DEV NUMBER: DEV25-0151	ORIGINATOR: Roberto Guzmán	DATE: 6-May-25	RAIN BIRD DEVIATION FORM (DRAWING) FORM#233813-01 REV: R		BUSINESS UNIT (SBU and PLANT) W/ PRIMARY DESIGN CONT 025 OTY >> LND	SHEET: 1 OF 1
DMR# (IF APPLICABLE):	DEVIATION TYPE: EXTENSION <input checked="" type="checkbox"/> OF DEV#:			AFFECTED MFG PLANTS (WHERE USED):		
TOP-LEVEL SKU P/N(S) AND MODEL NUMBER(S): A50792, A51021, A51058, A51063, A51095, A51214, A51224, A51230, X64000, X64036, X64039			EFFECTIVITY DATE: 6-May-25	EXPIRATION DATE: 10-Aug-25	005 LAM <input type="checkbox"/> 013S STL <input type="checkbox"/> 025 OTY <input checked="" type="checkbox"/> 041 NOG <input type="checkbox"/> 008 BUY <input type="checkbox"/> 019 AZU <input type="checkbox"/> 028 TUC <input type="checkbox"/> 047 TUC <input type="checkbox"/> 013E EEX <input type="checkbox"/> 020MX NMD <input type="checkbox"/> 026 ELG <input checked="" type="checkbox"/> CHINA <input type="checkbox"/>

DRAWING NUMBER:	DRAWING REVISION:	DEVIATION REVISION:	DRAWING TITLE/ PART DESCRIPTION:		VENDOR:	APPROVALS (ALL REQUIRED):
177449	C	C2	STREAM 360, MICRO SPRAY		RB El Lago	QUALITY MGR. OR QUALITY ENG. Indira Aragón / Ramiro Casas
						MANUFACTURING ENGINEER

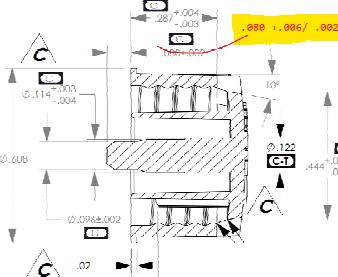
PROJECT NAME OR NO. (OPTIONAL):						
REASON FOR DEVIATION: Conditional approval of QAP1001 for P/N 177449, mold 45117 @ El Lago Molding Facility with optimal process, accepting described conditions and the recommended deviated allowances: 1. .080" +.006" / -.002", CPK 1.0885 proposing .081" +/- .004", CPK 2.30 2. Porosity, weld lines, mold marks, inner rib short shot and drag marks are acceptable. This conditions occurred also when molding in China and Nogales Be aware that we don't have material available and need to build units to cover backlogged orders.						
RISK ASSESSMENT/ CORRECTIVE ACTION PLAN (NAMES & DATES)/ COMMITMENT: Risk assessment: Low: 700 assemblies were tested for leakage at closed position in Arimex. 90 assemblies leaked below 20 ml/min. 610 assemblies did not leak. Corrective action plan: 1. Review component design to standardize features in product family Roberto Guzmán May 25, 2025 2. Identify differences and have a clear path to update design intent Roberto Guzmán June 15, 2025 3. Propose design changes Roberto Guzmán June 22, 2025 4. Test design proposal Roberto Guzmán / Delfino Ramírez / Omar Curiel August 31, 2025 5. Implement design changes Roberto Guzmán / RB El Lago Team December 28, 2025
